MEMORANDUM

SUBJECT: Site Plan Approval – 111 Breen Avenue

DATE: December 1, 2022

Request: Site Plan Approval for a 12,632 SF parking lot expansion and associated site improvements at 111 Breen Avenue, Parcel Number 8-01-214.100

C101

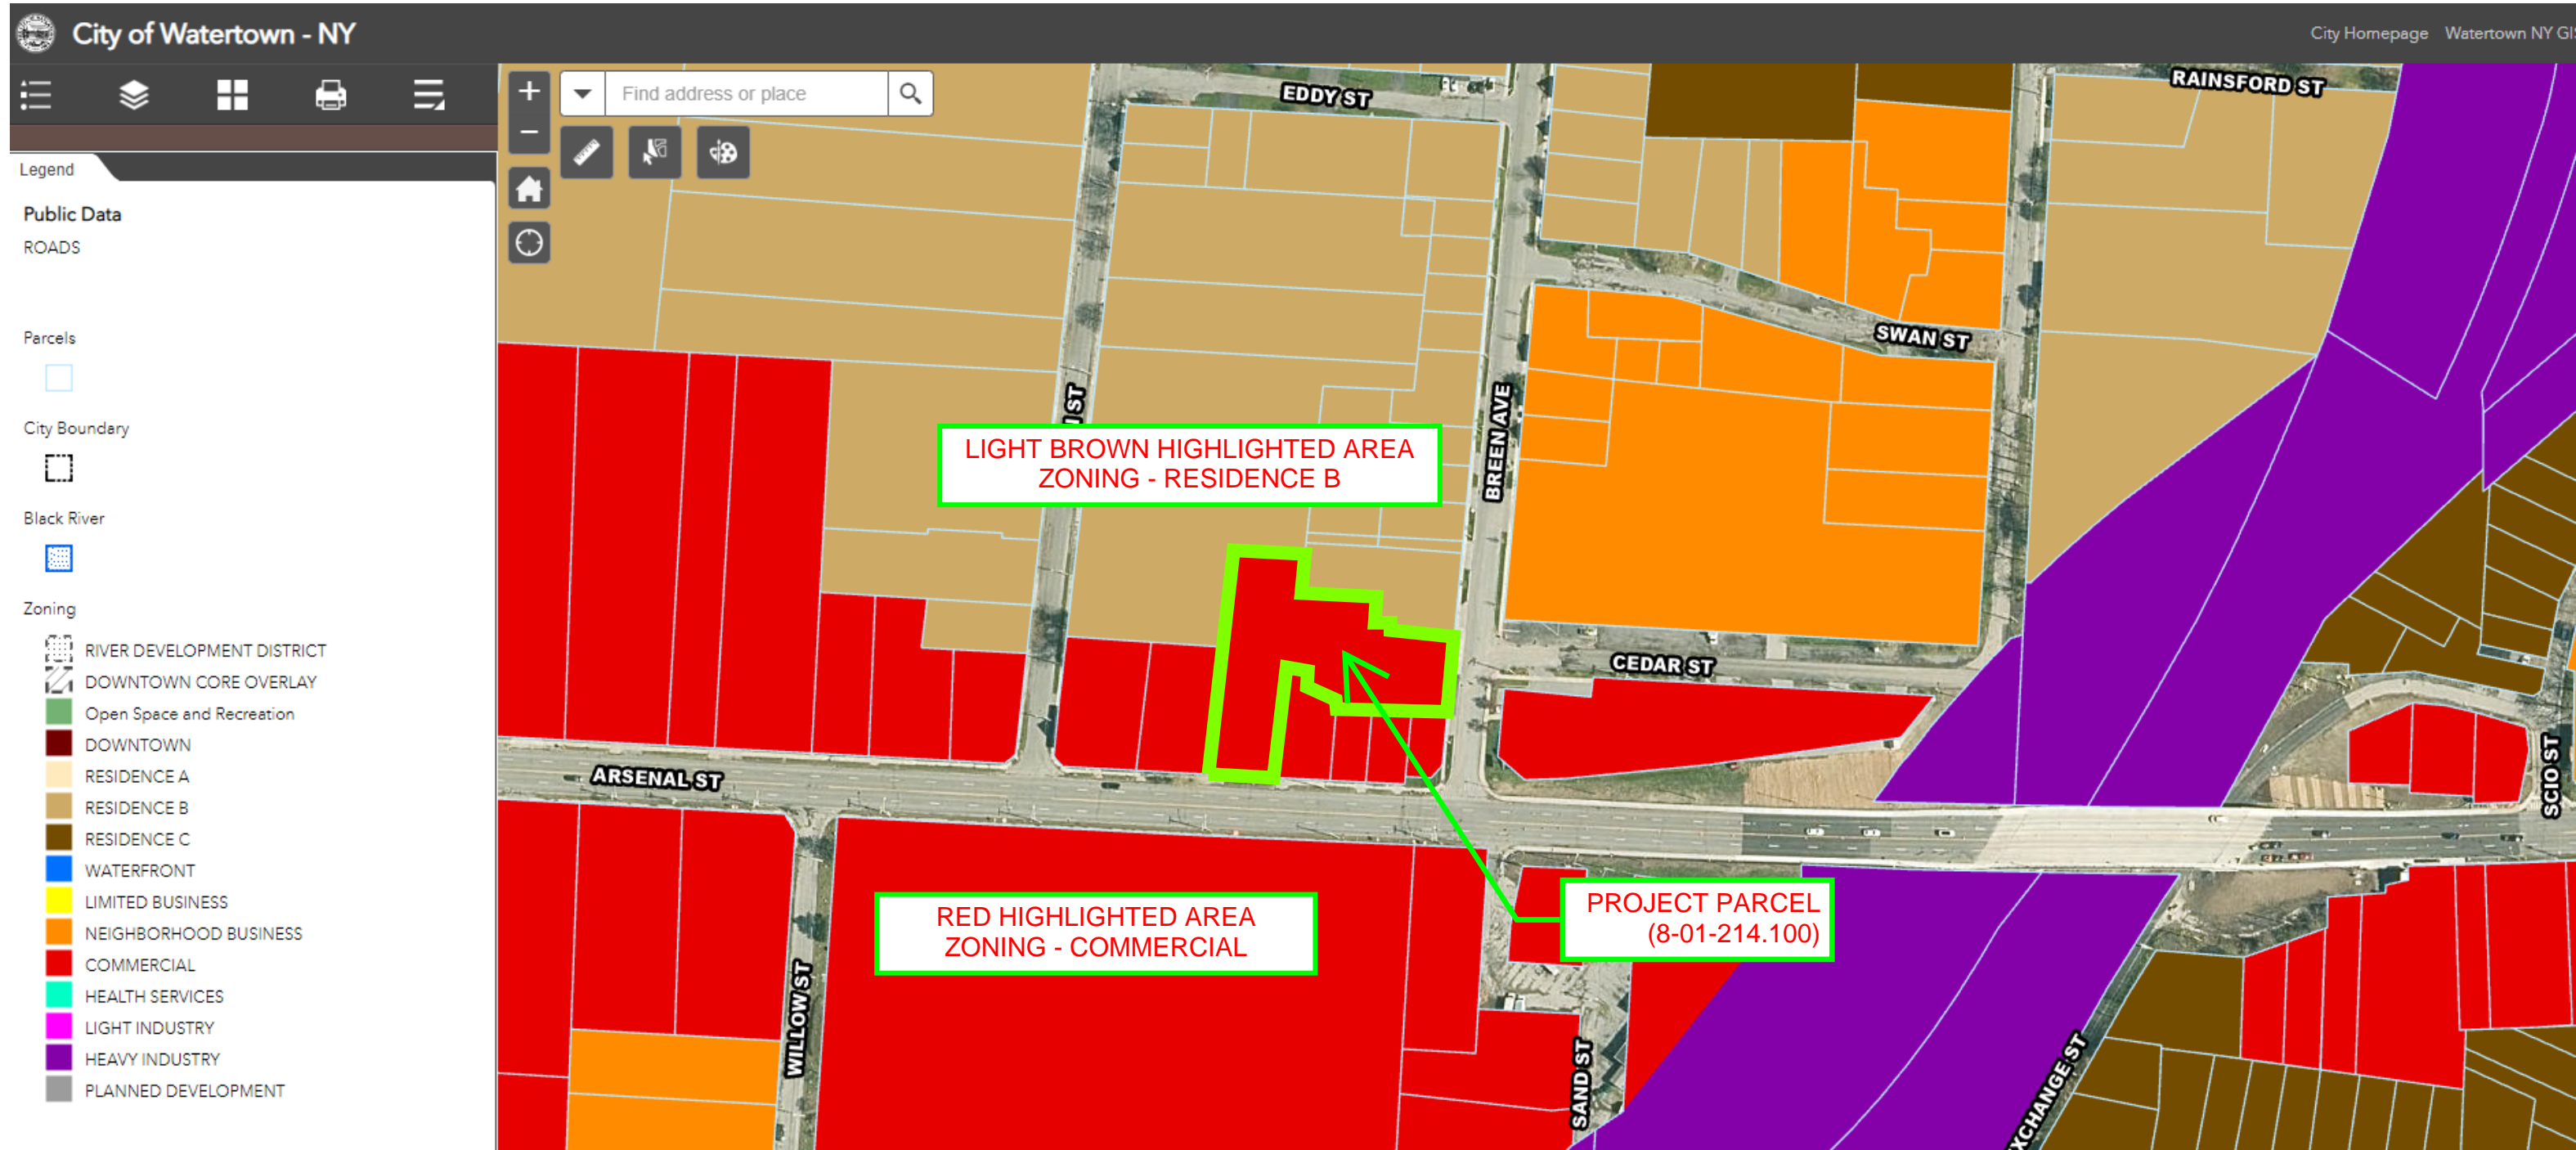
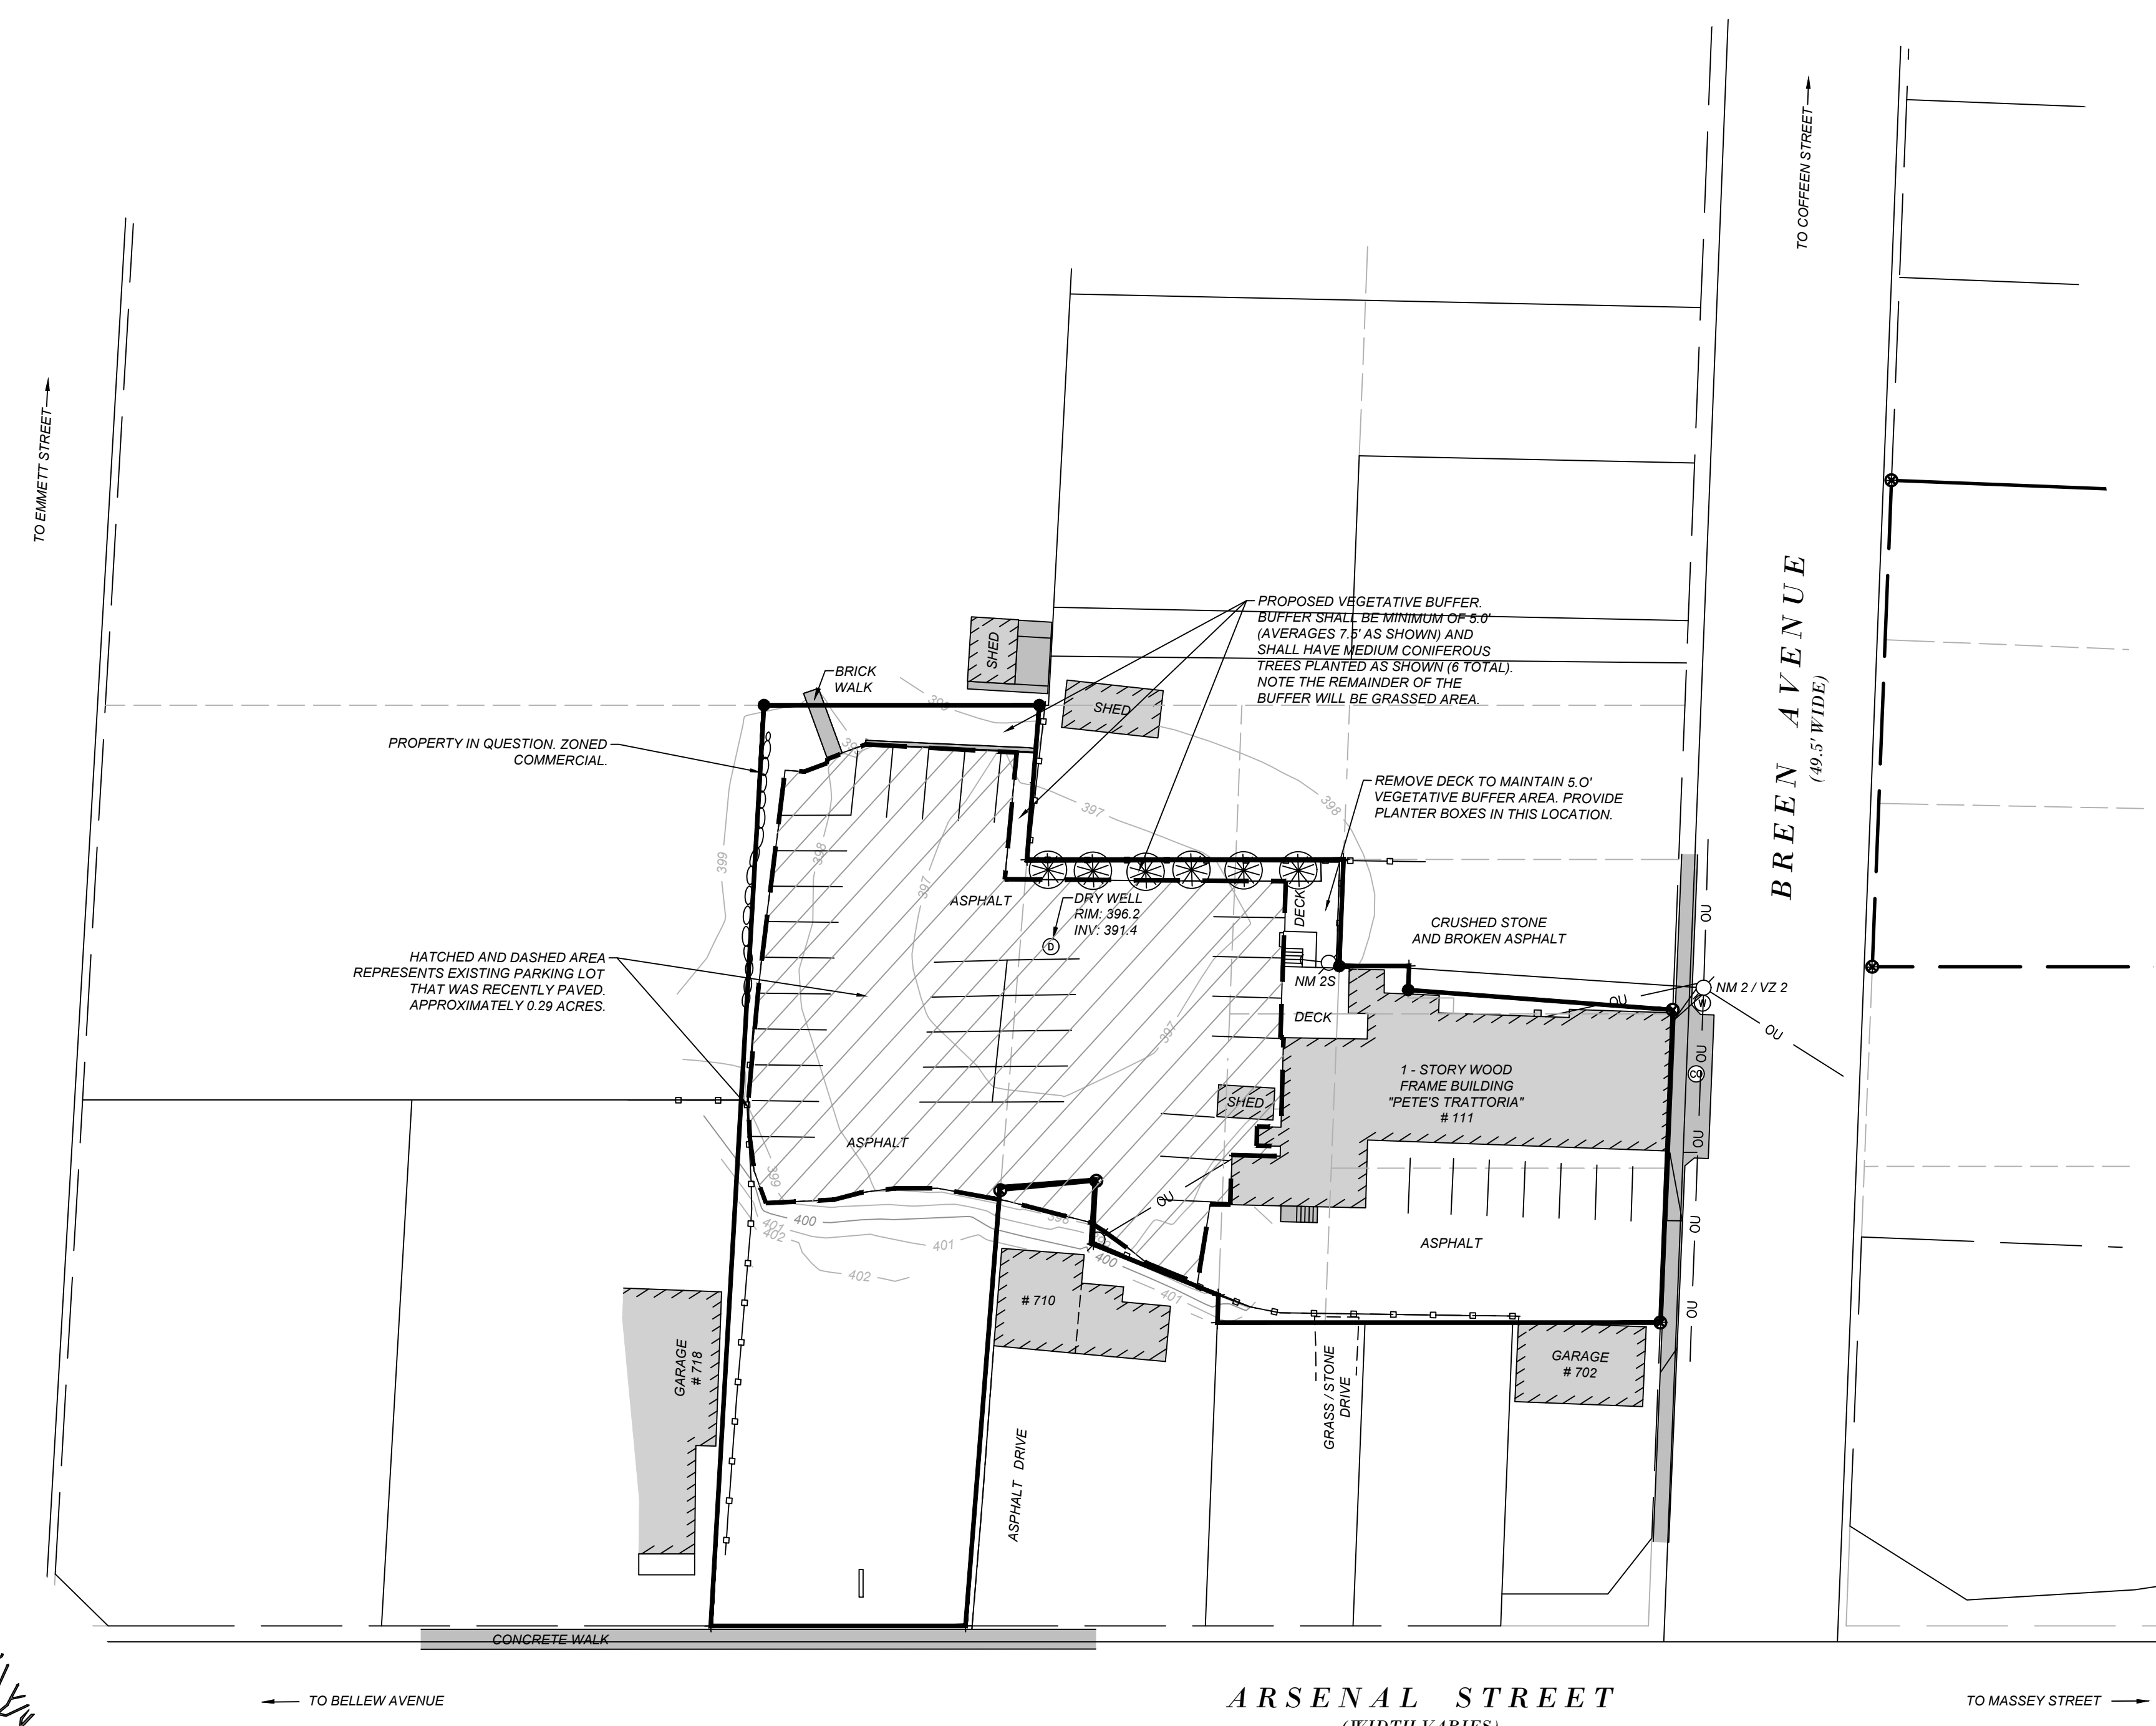
1. The applicant shall install planter boxes, as proposed and depicted on the site plan, along the north-south property line with 119 Breen Avenue to the north of the existing deck to fulfill the five-foot buffer requirement.
2. The applicant must indicate to Staff and the Planning Board that any light spillage across onto the parcel at 710 Arsenal Street is within acceptable limits.
3. The applicant shall address the adequacy of illumination of the westernmost parking bay on the site.
4. The applicant shall submit a revised and signed SEQR Short EAF prior to the City Council considering Parts 2 and 3.
5. The applicant must obtain a Zoning Compliance Certificate.

During the review the County Planning Board identified the local advisory comment that the local board should require the applicant to depict the snow storage and dumpster location on the site plan.
